Environment Agency Review Response

Henley Road, Caversham modelling

Project Name: Caversham, Henley Road Phase 2
 Project Number: EVY0720
 Revision: A
 Client: Environment Agency

Figure 2.3: Historical flood extent map showing the approximate outlines of the 1947, 2003 and 2014 flood events.

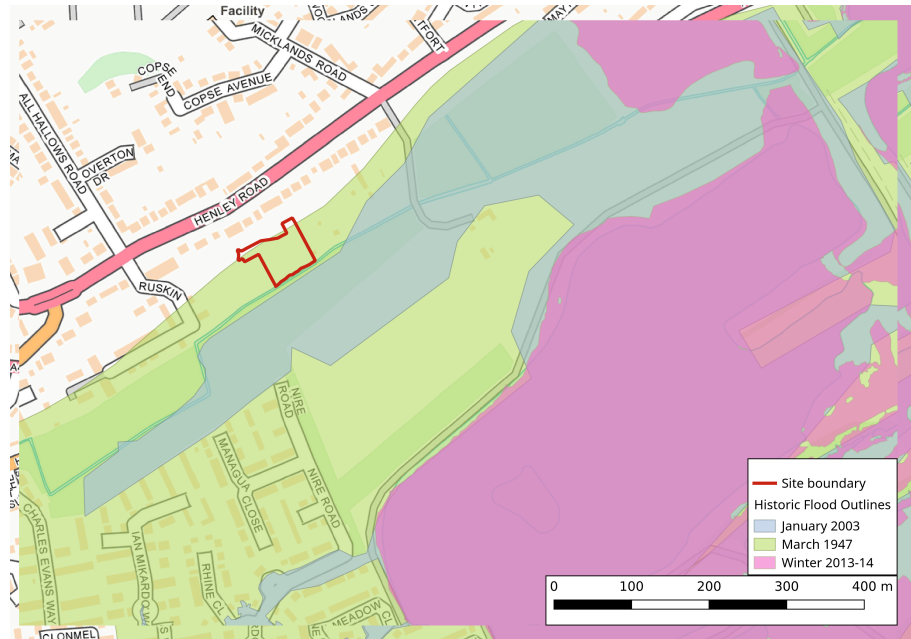
- Since 2011, there was a significant flood event in the area (2013). As the hydrology is heavily based on the 2011 analysis, this has not been captured. Please either update or provide justification on why this is not required. - Has the site got a flood history/ did the site flood in the 2003 event in which the Jacobs (June, 2011) report stated 4 properties in Caversham flooded? - The 2011 approach is deemed appropriate; however, the 2013- 2014 flood could heavily affect the design flows. No checks undertaken in this respect. - Please expand on comparison between design flood maps and flood history at the site. - Appendix A shows the Berry Brook as an excluded main river from the model at the location of the site. The site appears to be close to the source of this Brook but the Brook flows next to the site/ bounds the site to the south. No commentary is supplied on this. Has any attempt to identify flood risk from the Berry Brook been undertaken? - The proposal is to build new dwellings. The Edenvale Young figures, for example Figure 5.5, suggest 9 dwellings and associated infrastructure such as parking space. This would increase the area of hard standing. Any changes to surface area risk should be investigated and appropriately mitigated against?		ACTION REQUIRED

The map shown in Figure 2.3 shows that flooding may have occurred on the site in the March 1947 flood event.

According to the Environment Agency recorded flood extents, other major flood events such as those in 2003 and 2013/4, did not impact the site, despite flooding being experienced in other parts of Reading and Caversham.

From the available information, it appears that the March 1947 flood event may have been the only event to have flooded the lower lying area of the site although the accuracy of the EA historical flood outlines are not always consistent or reliable.

Based on inspection of the LiDAR data, the site (left bank of the Berry Brook) sits approximately 1m higher than the right bank of the Berry Brook and most of the flood plain. The January 2003 recorded extents show right bank flooding of the Berry Brook whilst the site remains dry (Figure 2.3).
